Meeting of the Upper Thames River Conservation Authority  
Hearing Committee – Agenda  
Friday December 17, 2021 9:00am

**To:** Chair and Members of the UTRCA Hearing Committee  
**From:** Jenna Alain, Manager, Environmental Planning and Regulations  
Brent Verscheure, Land Use Regulations Officer  
**Date:** December 10, 2021  
**Agenda #:** 5  
**Subject:** Section 28 Permit Application #90-21 Proposed Replacement Structure in the Floodway, 2533 Gideon Drive, Delaware, Middlesex County

**To:** Chair and Members of the UTRCA Hearing Committee  
**From:** Jenna Alain, Manager, Environmental Planning and Regulations  
Brent Verscheure, Land Use Regulations Officer  
**Date:** December 10, 2021  
**Agenda #:** 6  
**Subject:** Section 28 Permit Application #120-21 Proposed Construction of a 12'-0" x 20'-0" Pool Cabana, 1326 Sprucedale Avenue, City of London

# Attachment 6 - Slope Assessment, Proposed Cabana - Site Plan and Cross Section

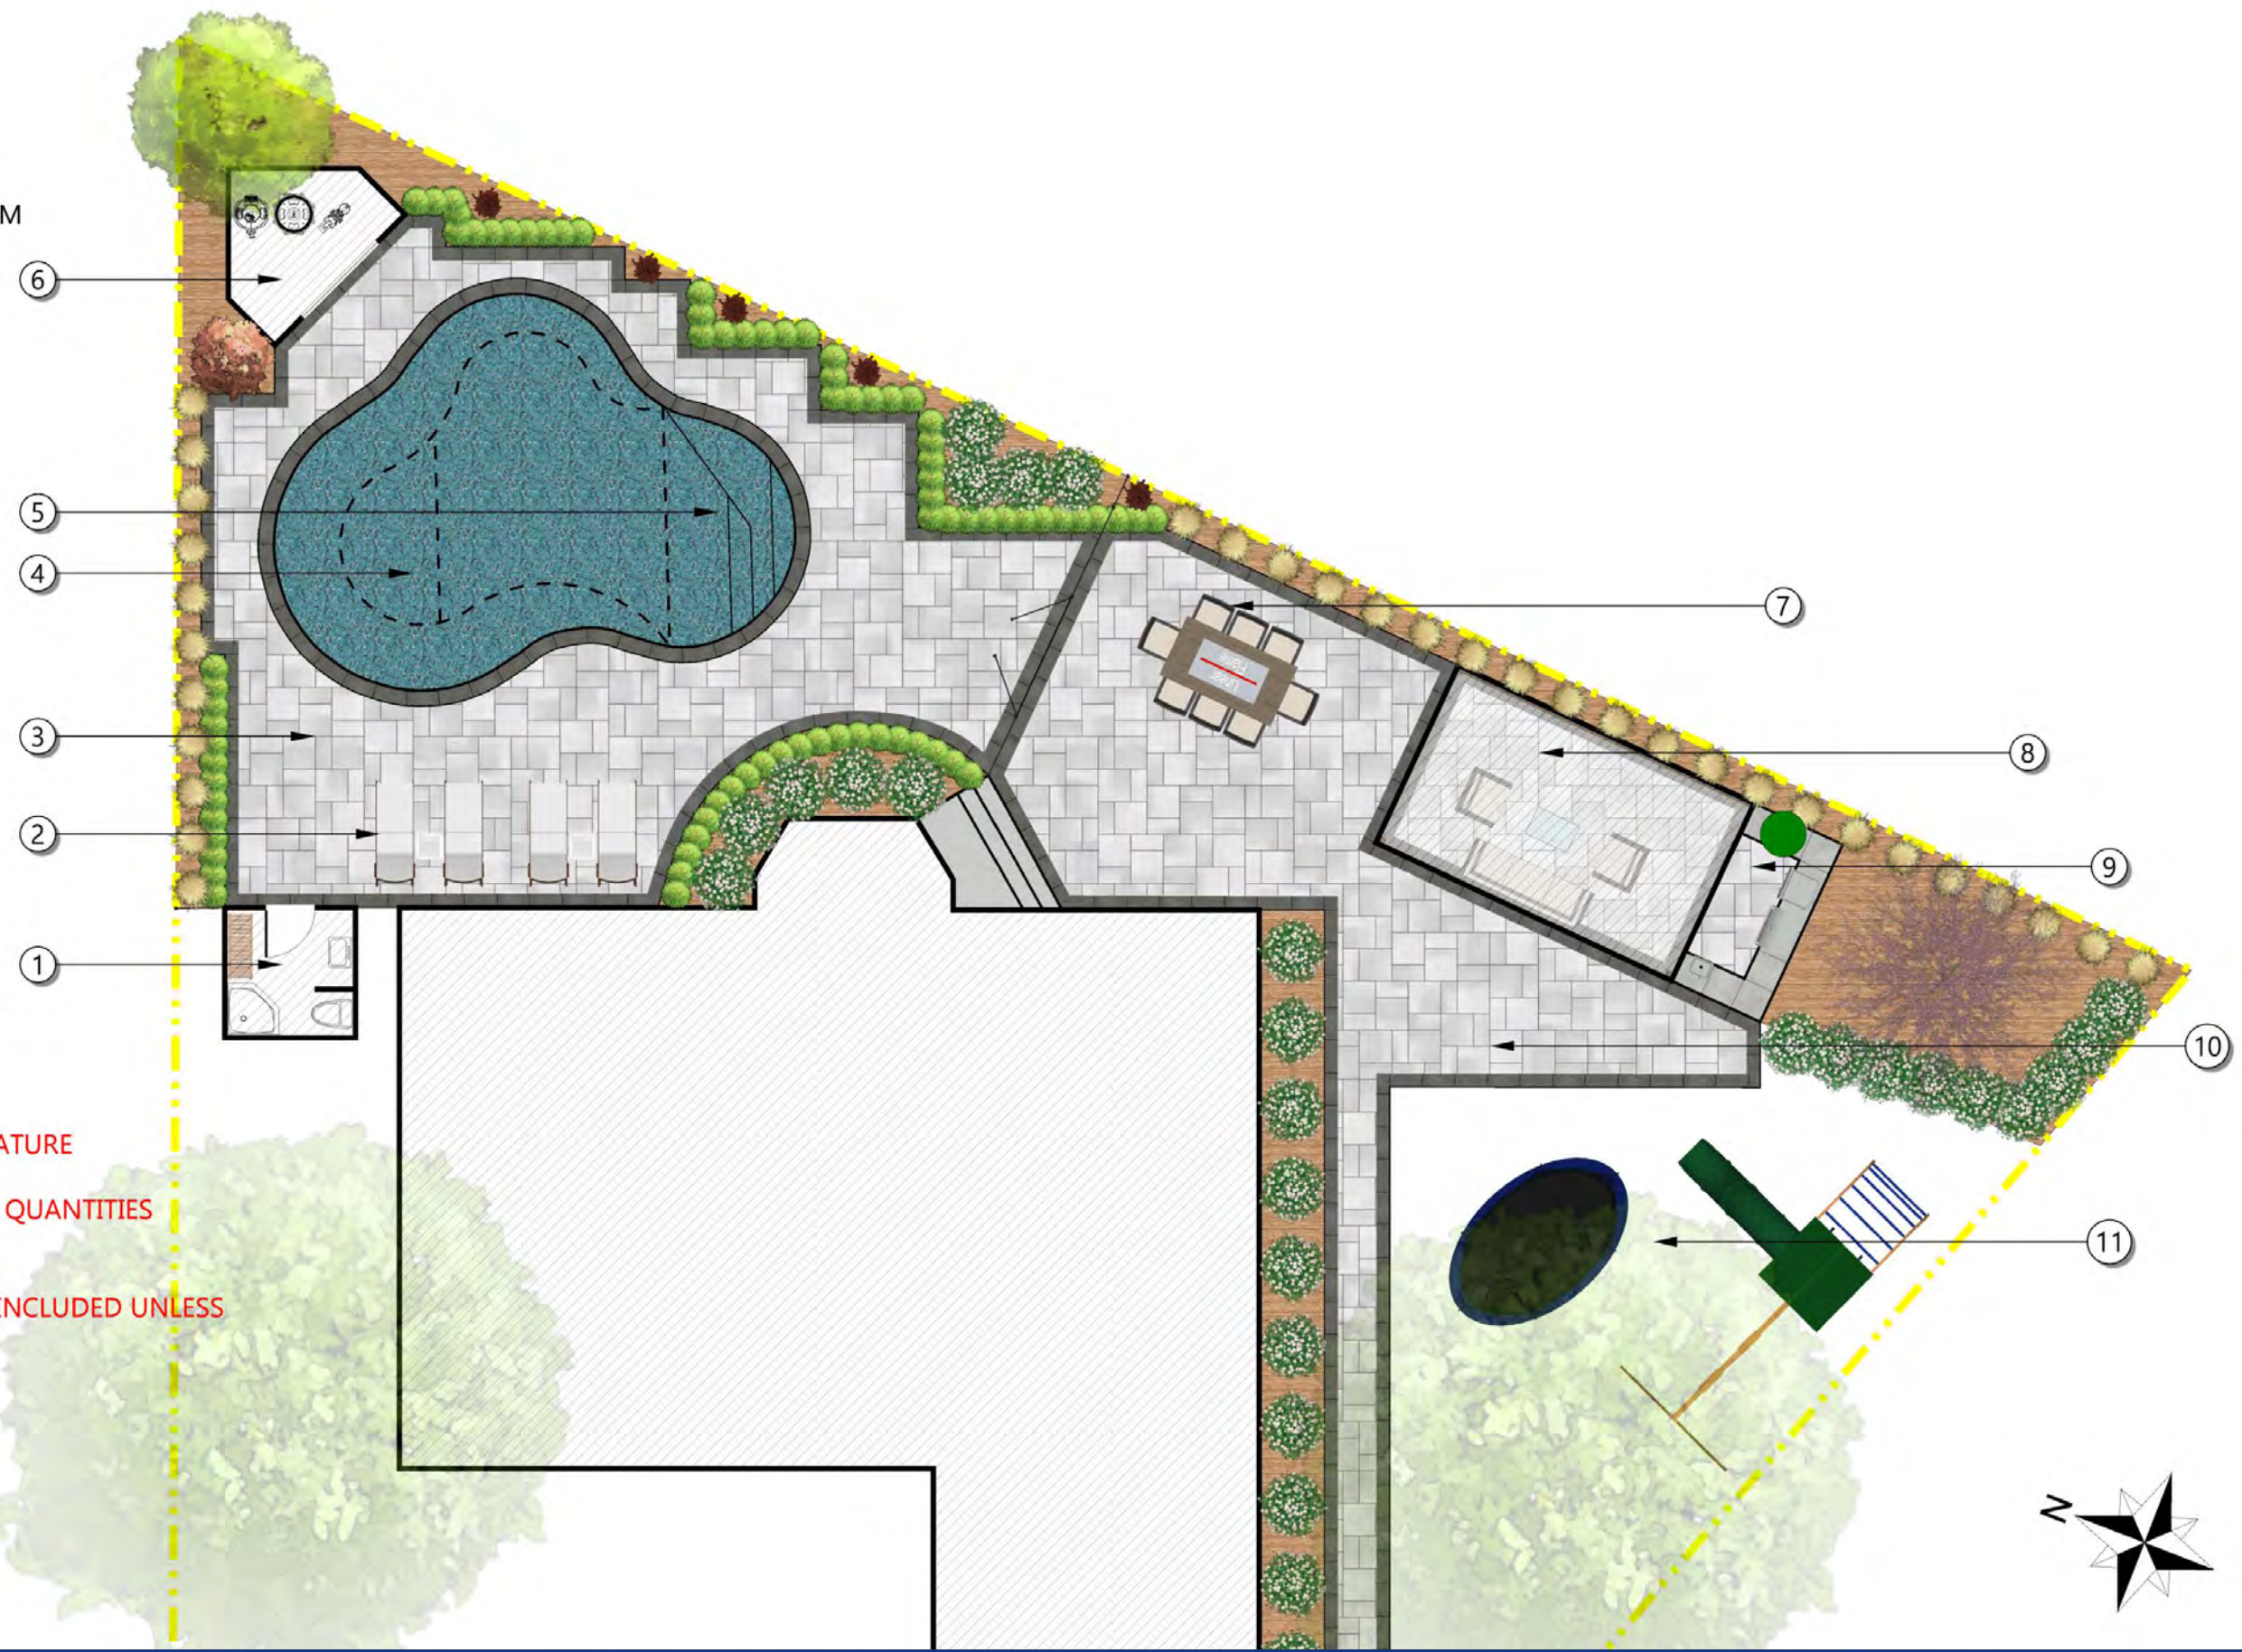
the 12'x 20' pool cabana could be moved to the existing trampoline and play area south of the existing dwelling (see Attachment \_7 – Concept Plan), that this potential for a revised proposal would ensure the pool cabana would be located sufficiently away from the top of slope and outside of the hazard lands, to ultimately gain support by UTRCA staff.

UTRCA staff is seeking direction from the Hearings Committee on this concept plan and application for development, with consideration for the UTRCA policy framework for new development in hazard lands and the disregard for provincial technical guidelines. As mentioned above, there is an opportunity and development 'envelope' to relocate the proposed pool cabana to an area outside of the hazard lands. However, should the Hearings Committee decision be favourable for the applicant to proceed, staff will reference the slope stability assessment in an approval letter, and require the presence of a qualified on-site geotechnical inspector throughout construction.

# CROSS SECTION A-A'

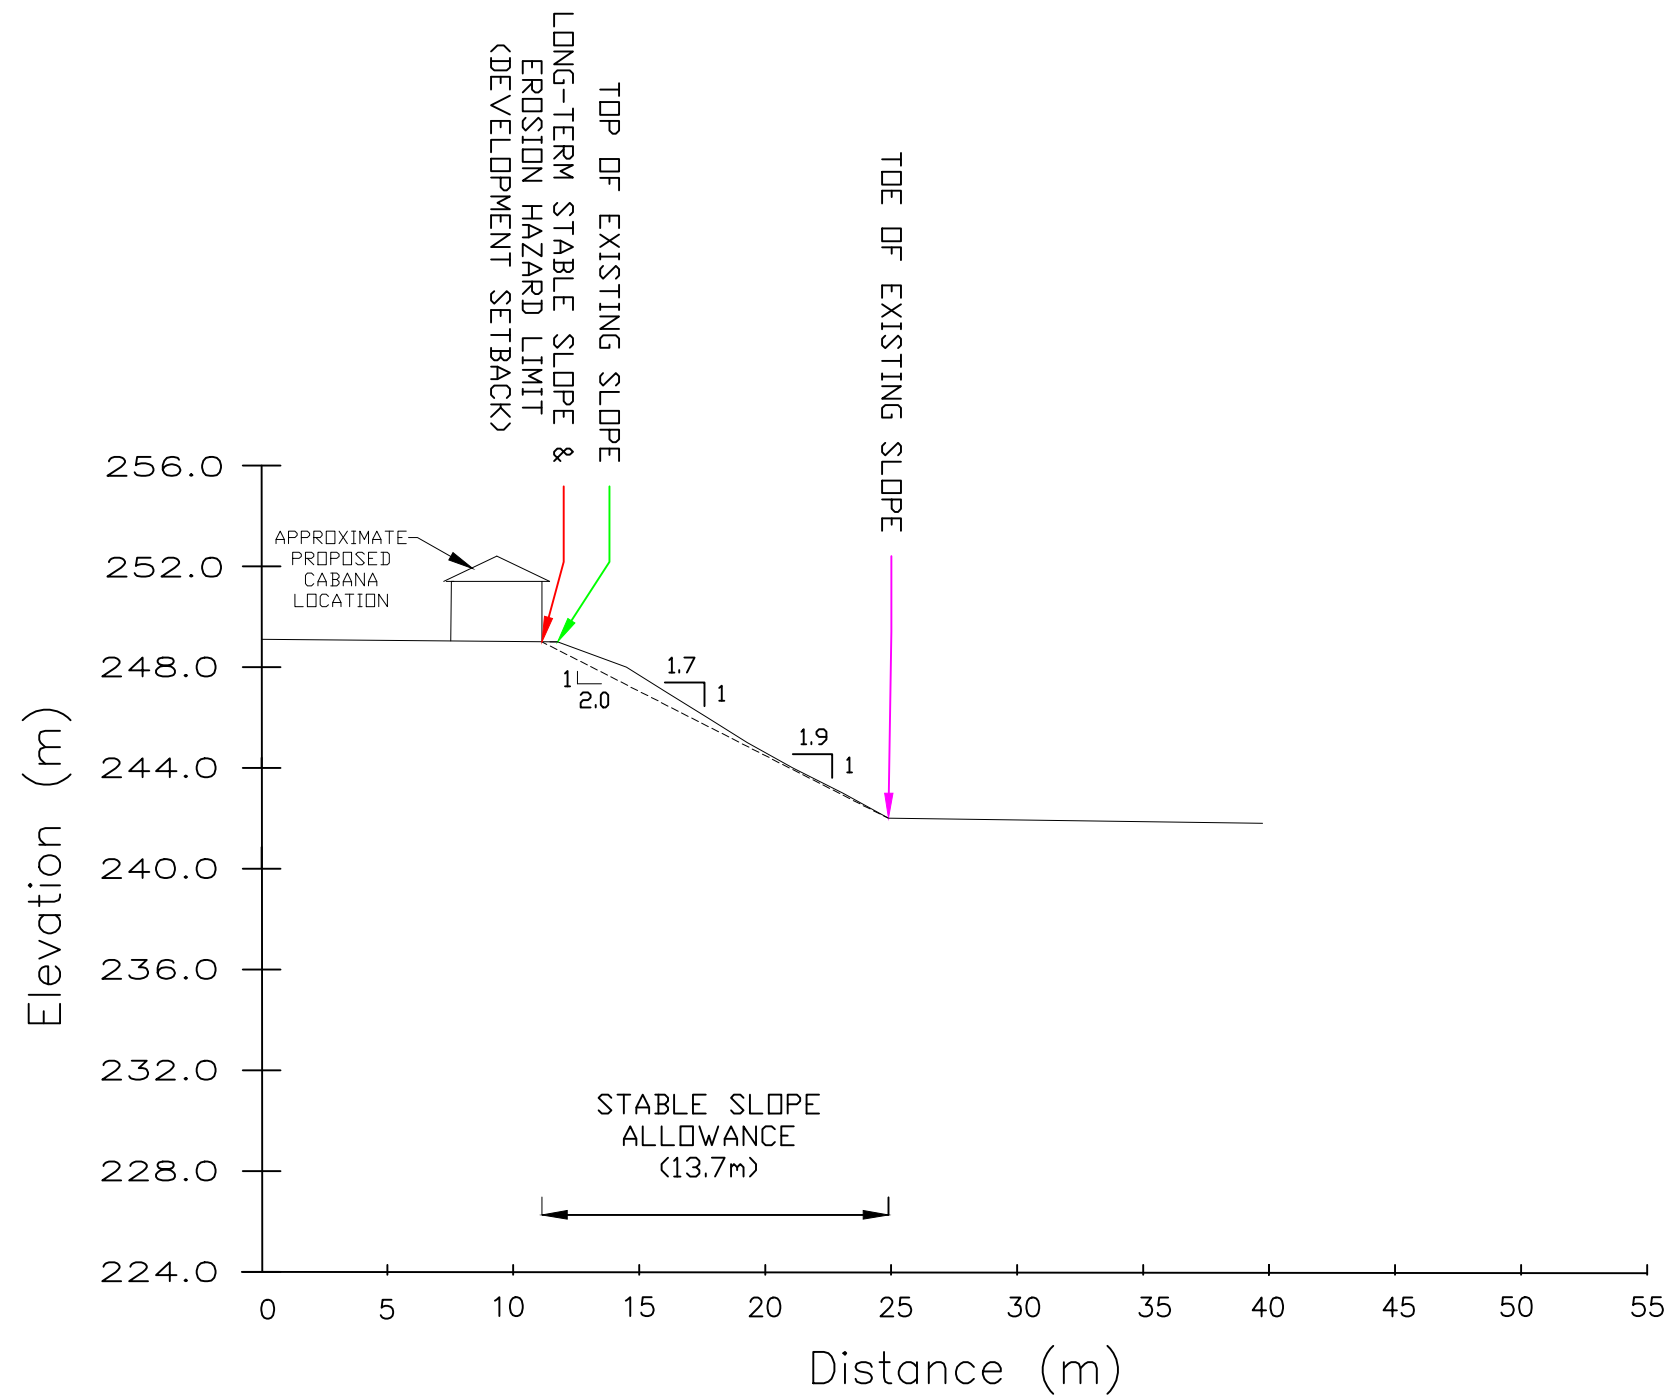
One cross section was assessed in the area of the proposed cabana and was generally selected to represent the worst-case-scenario of the slope. The cross section location is shown on **Drawing 1** with the profiles provided on **Drawings 2**. The failures at the cross section consisted of shallow, moderate depth and deep rotational failures for both existing and post construction conditions. Summarized results are provided in the following table:
